REPLACEMENT SYSTEM VARIANCE REQUEST

GENERAL INFORMATION
Town of AUGUSTA
Permit No. 4898
Date Permit Issued 7/16/02
Property Owner's Name: FRANCIS HEALY Tel. No.: 547-4958
System's Location: TOGUS STREAM ROAD AUGUSTA
Property Owner's Address: R1 BOX 901
(if different from above) BELGRADE, ME 04917

Subject: Approval, Replacement System Variance Request, Healy property, Togus Stream Road, Augusta

SUBSURFACE WASTEWATER DISPOSAL PLAN

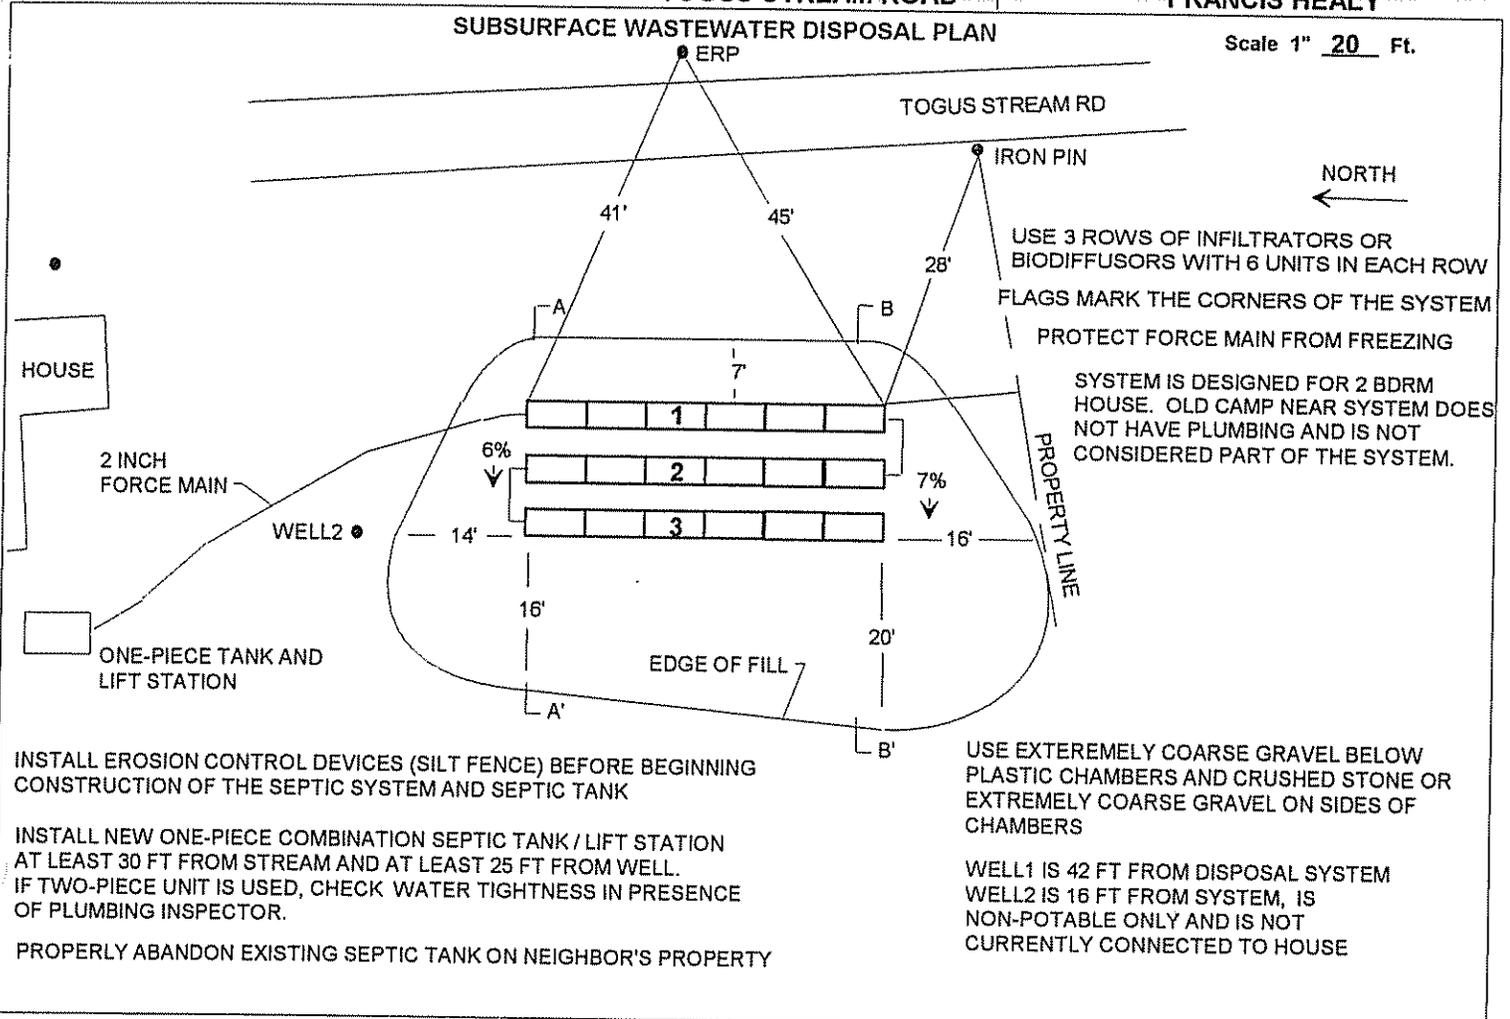
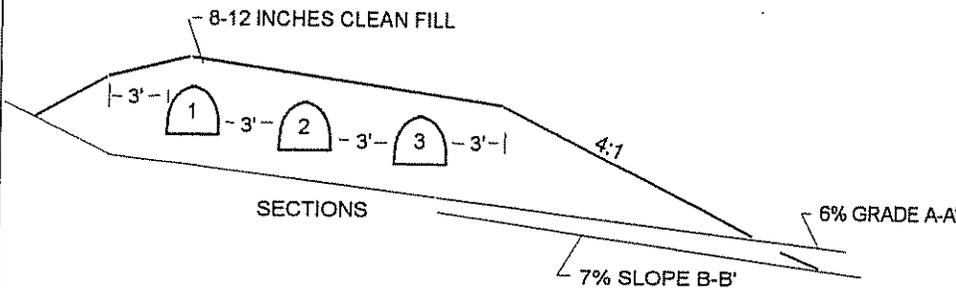
The Division has reviewed a Replacement System Variance Request for the subject property. The variance requested is to allow the installation of an onsite sewage disposal system with a setback distance reduction from the owner's well to the disposal field of 42 feet, septic tank of 25 feet and a major watercourse to the septic tank of 30 feet. Another variance required is a setback distance reduction from a major watercourse to the disposal field of 61 feet. The system design, prepared by William Brown, SE, dated June 4, 2002, is otherwise found to be in compliance with the Maine Subsurface Wastewater Disposal Rules.

We approve the requested variances with the following requirements:

1. A permit for system installation is to be obtained from the Local Plumbing Inspector in advance of the start of system construction.
2. The system is to be installed in accordance with the submitted and approved system design. Should alterations be required at the time of system installation, the system designer must be notified prior to making any changes.

3. The property owner shall complete the enclosed Well Setback Release Form and file it at the County Registry of Deeds, cross-referenced to the subject property's deed. A copy of the filed release, with Registry's stamp, shall be forwarded to this office to complete and validate the variance approval within 90 days of the date of this letter.
